Exterior Renovations
at

Cascadian Apartments 15517 NE 12th St., Bellevue WA 98007

February 23, 2024

ADDENDUM NO. 1

1 FOUNDATION & LEVEL 1 FLOOR PLAN
SCALE: 1/8" = 1'-0"
0 8' 16'

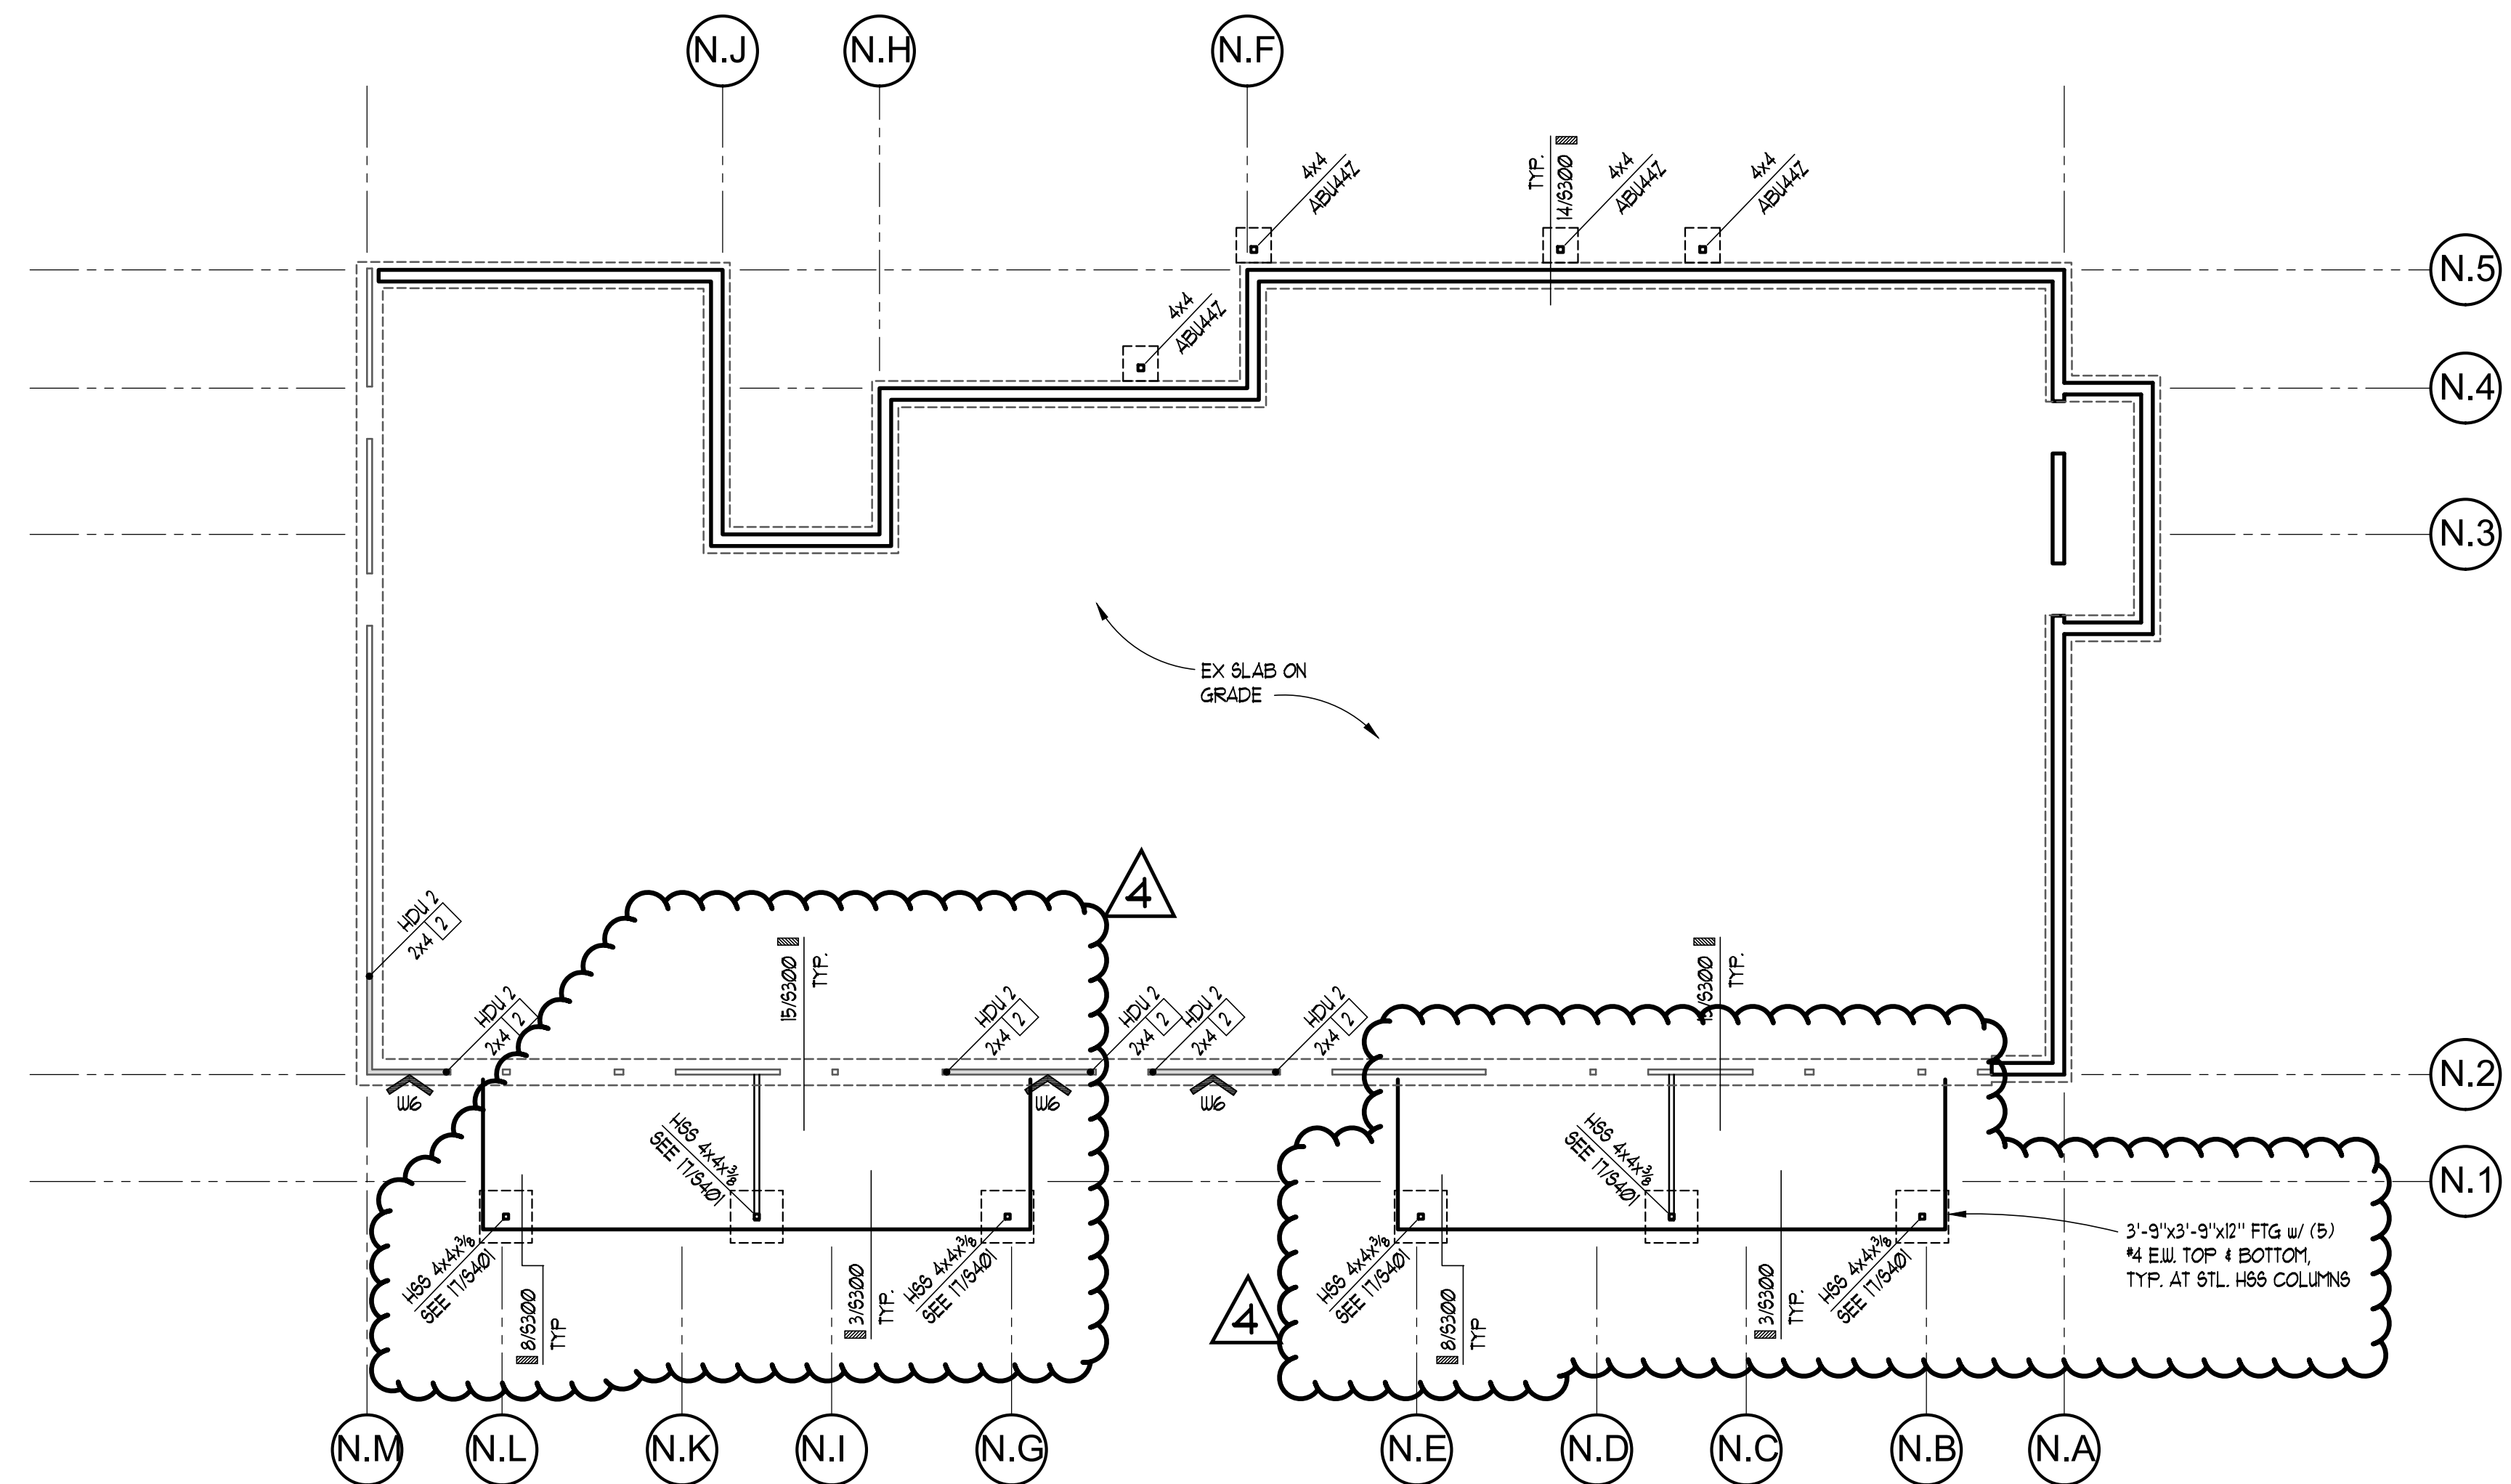
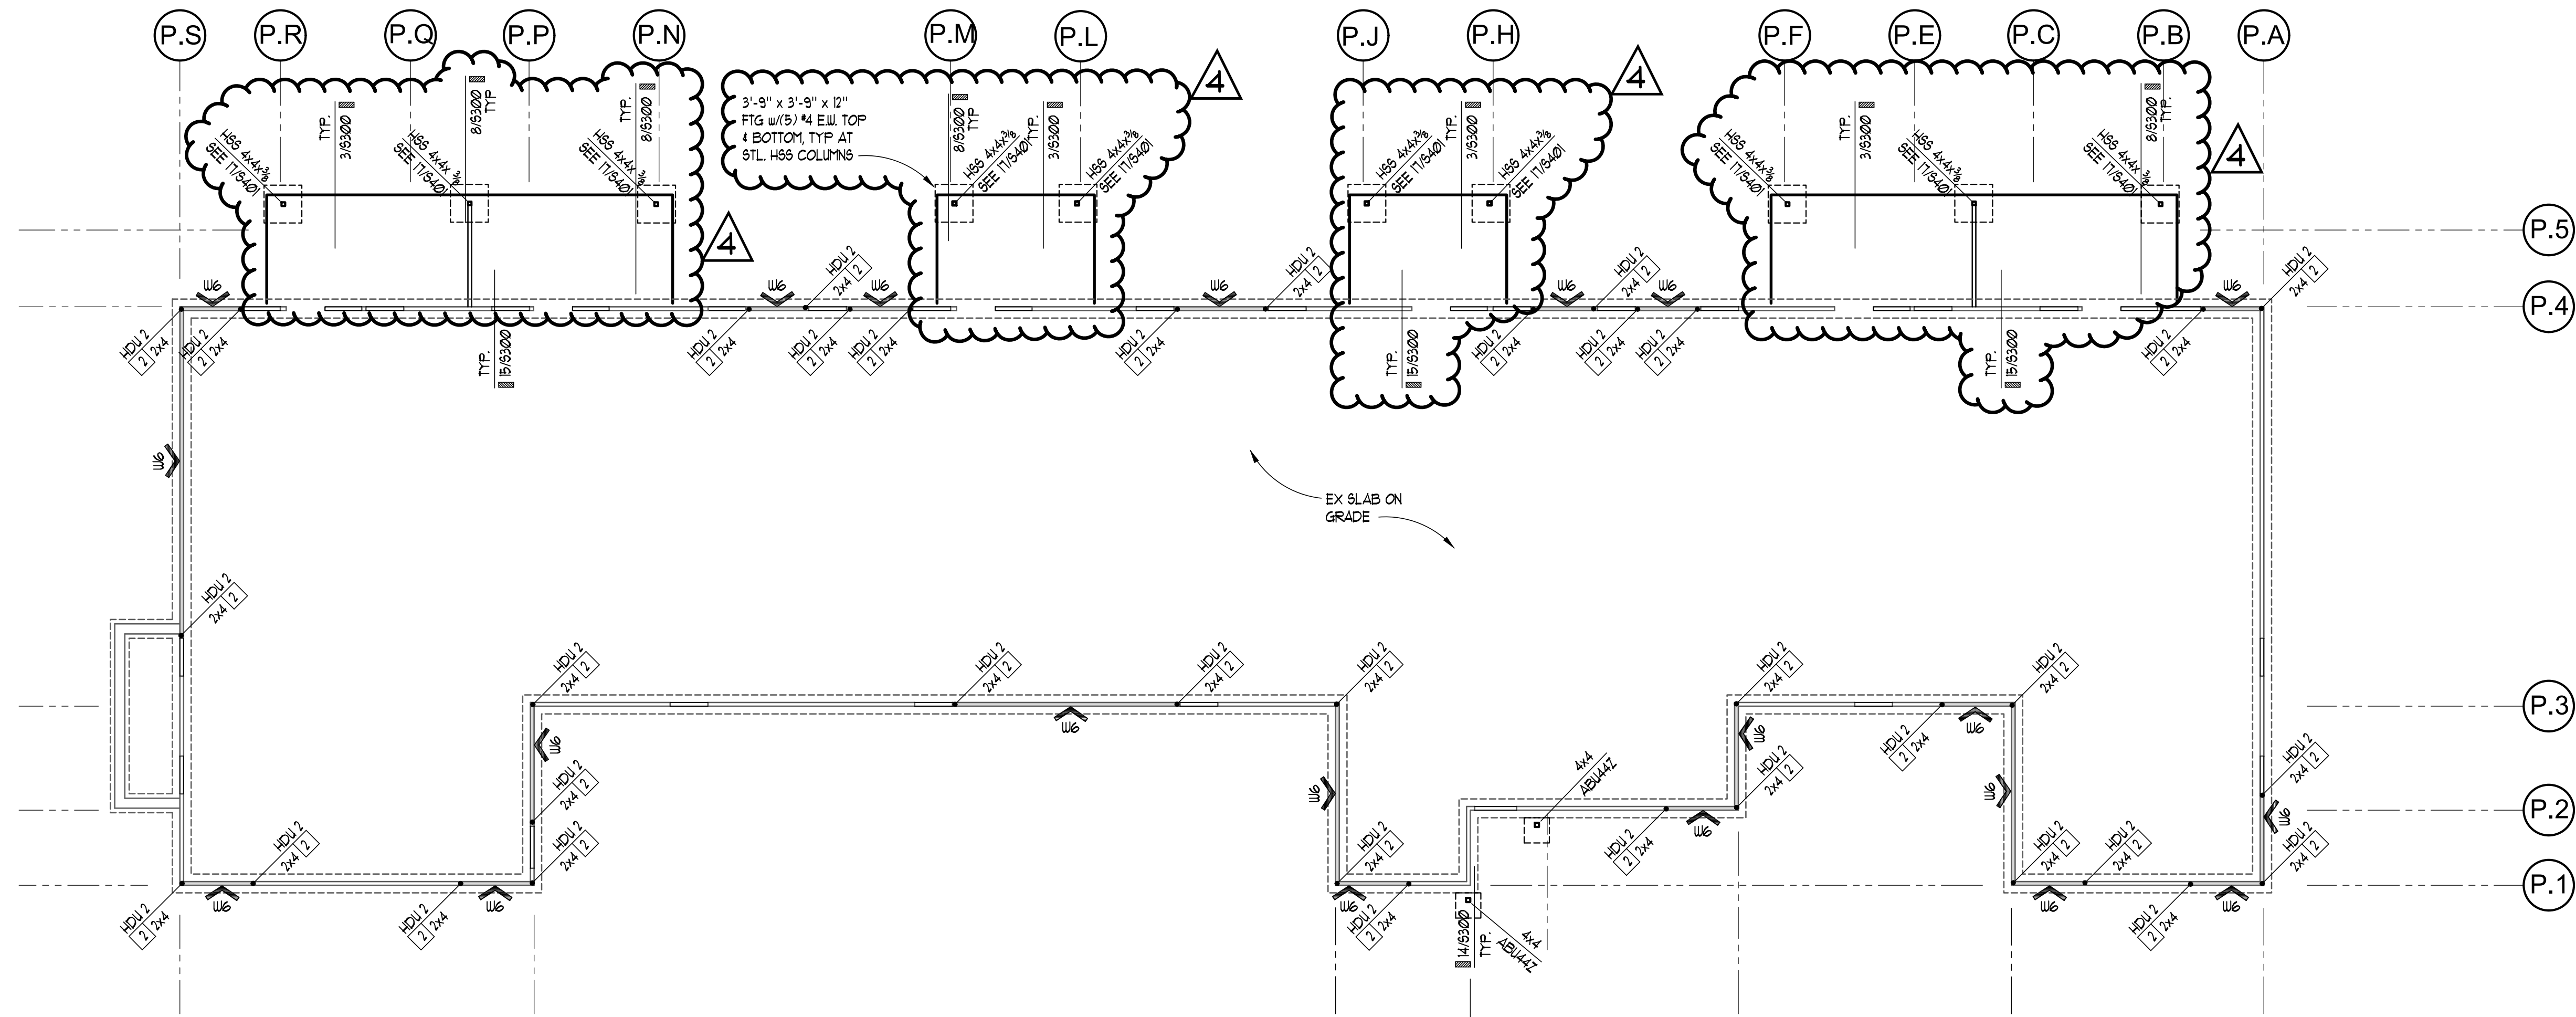
Q. 8. Patio Deck Column Footing / Turned Down Slab:

Sheet N-S200 Plan view shows a solid black line outside of the HSS Columns, noting detail 3N-S300. Detail 8N-S300 shows the turned down slab edge, pouring to the backside of the steel HSS columns, sitting on top of the spread footing.

What's the design intent, are we to pour the turned down slab per detail 8N-S300 to the back side of the HSS column?

A. See revised sheet S200 and S300 for Structural details.

1 ROOF FRAMING PLAN
SCALE: 1/8" = 1'-0"

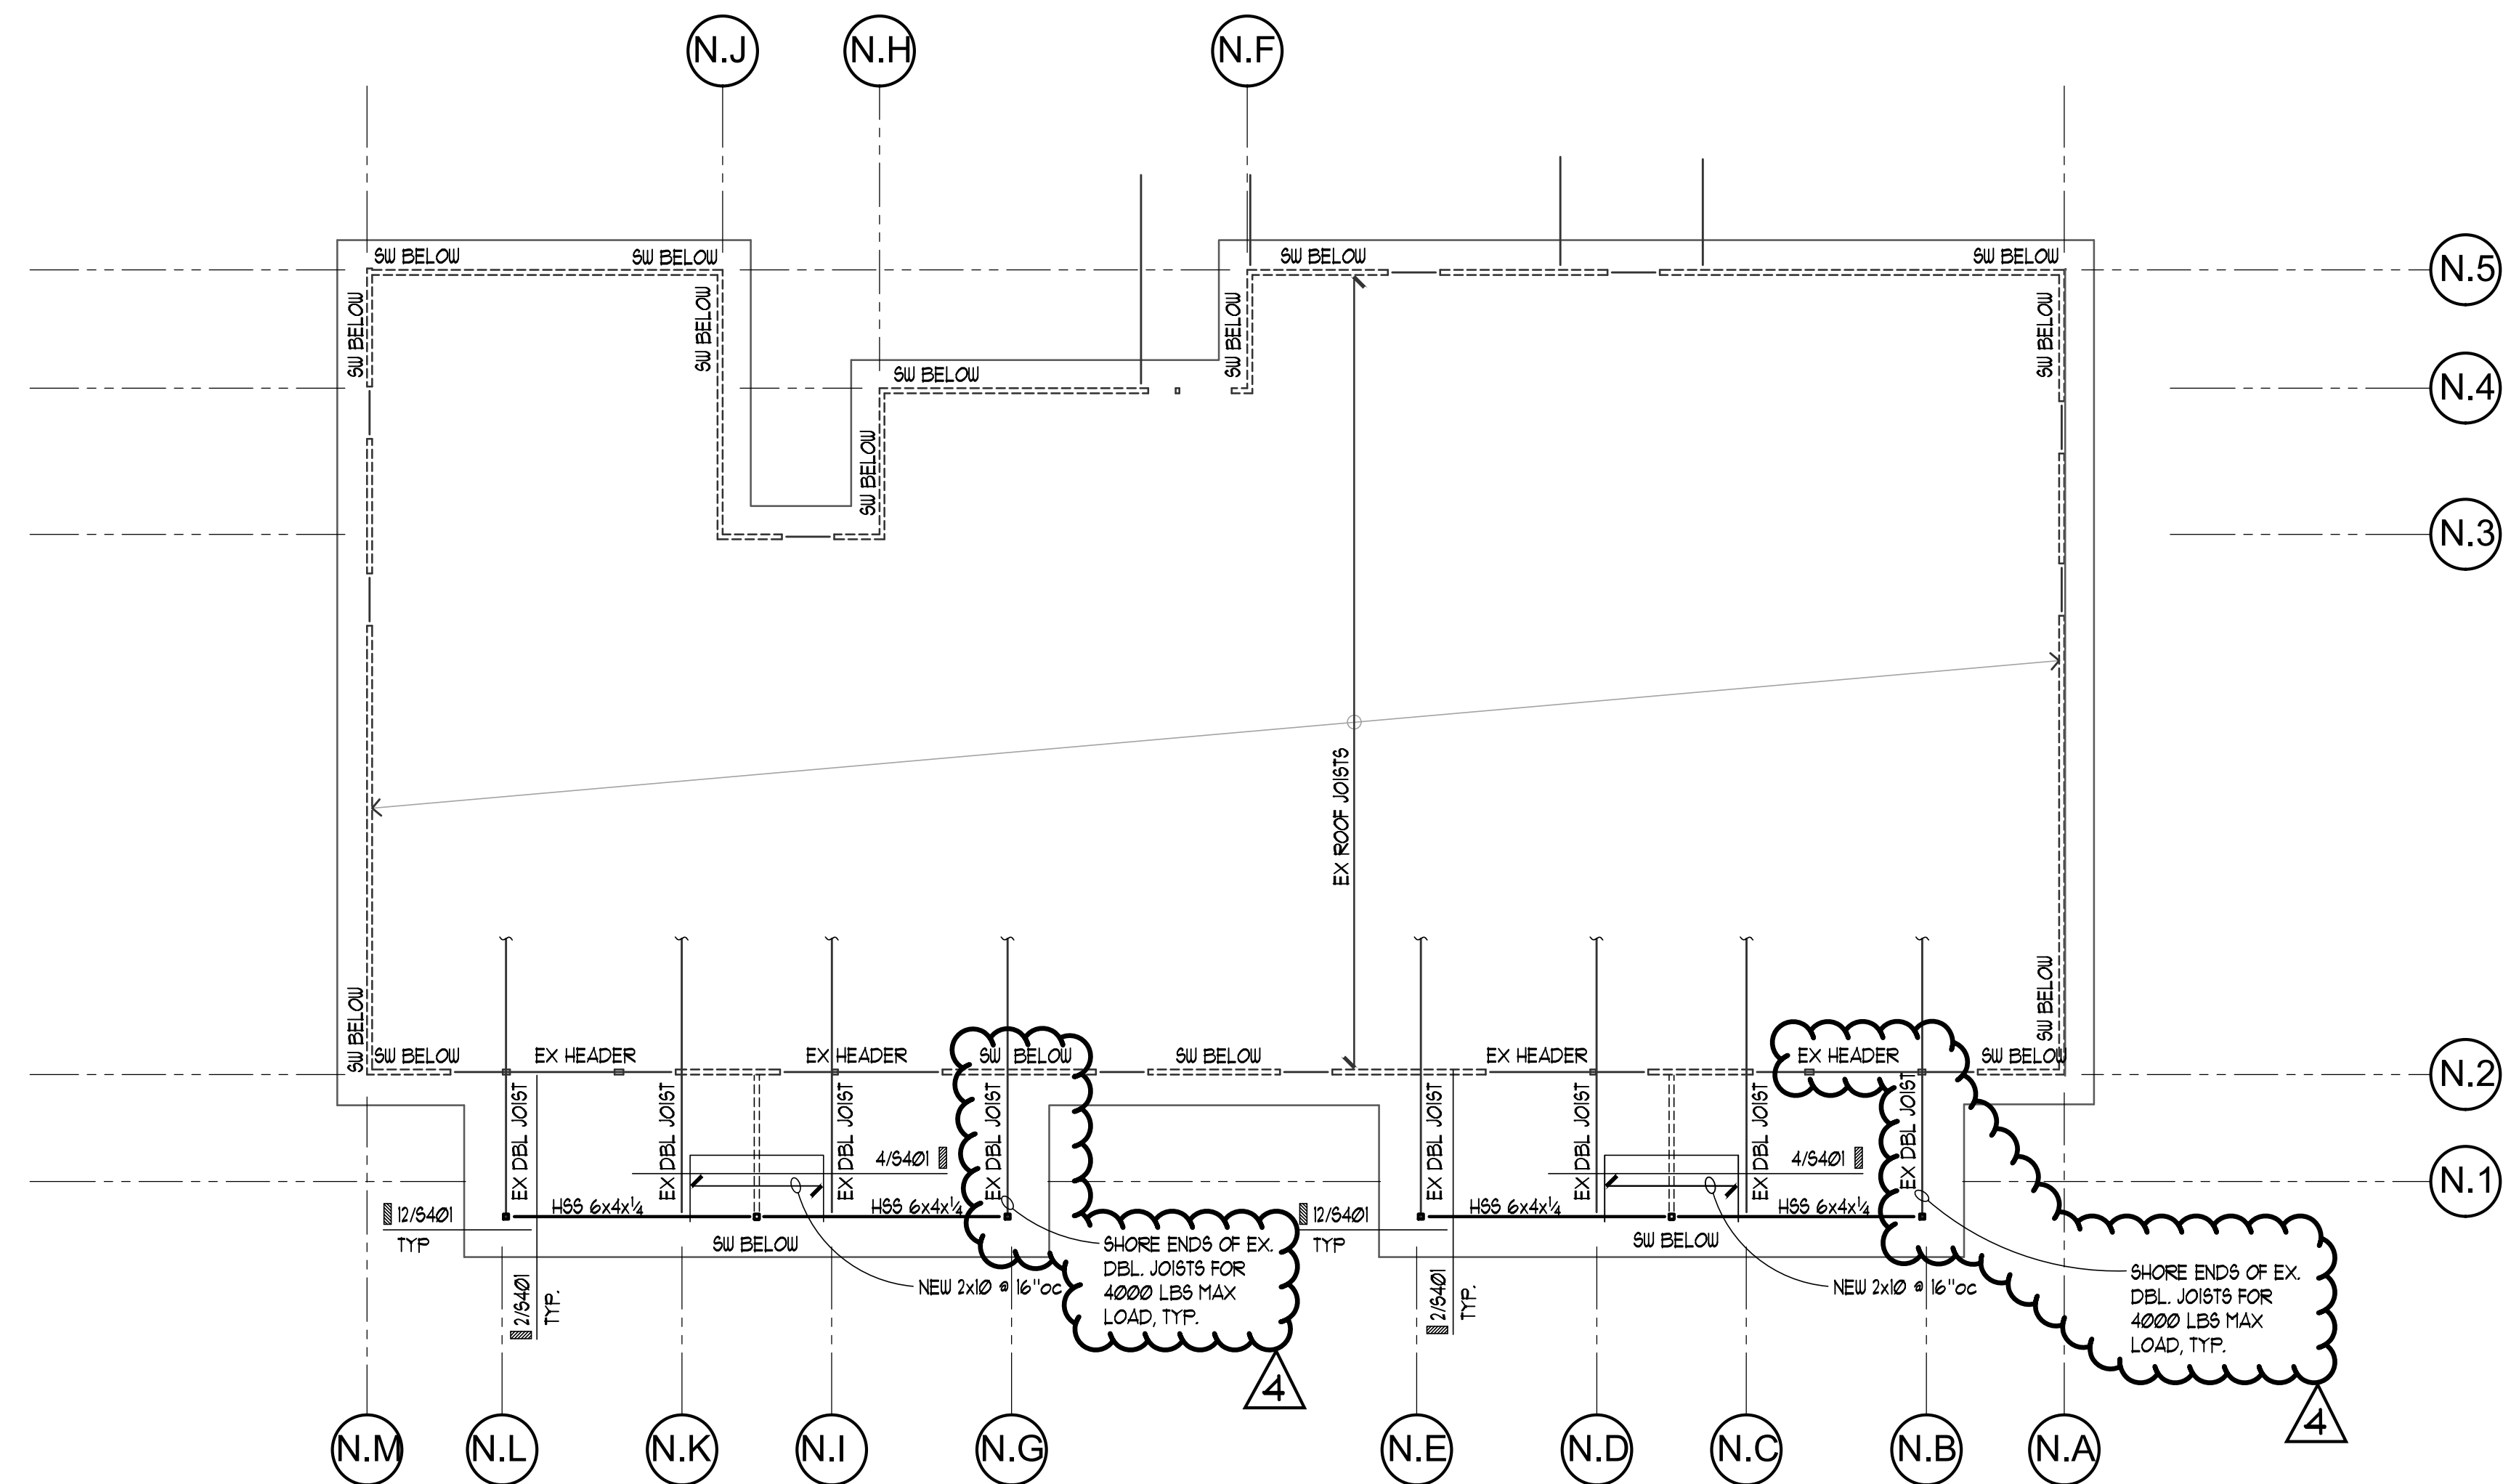
Q. 2. Roof Shoring- Do you have a shoring detail on how you want these roofs shored while decks are being rebuilt?

A. See revised sheet S203 for Structural notes on roof plan and leader indicating required loads for contractor to provide shoring as Means and Methods.
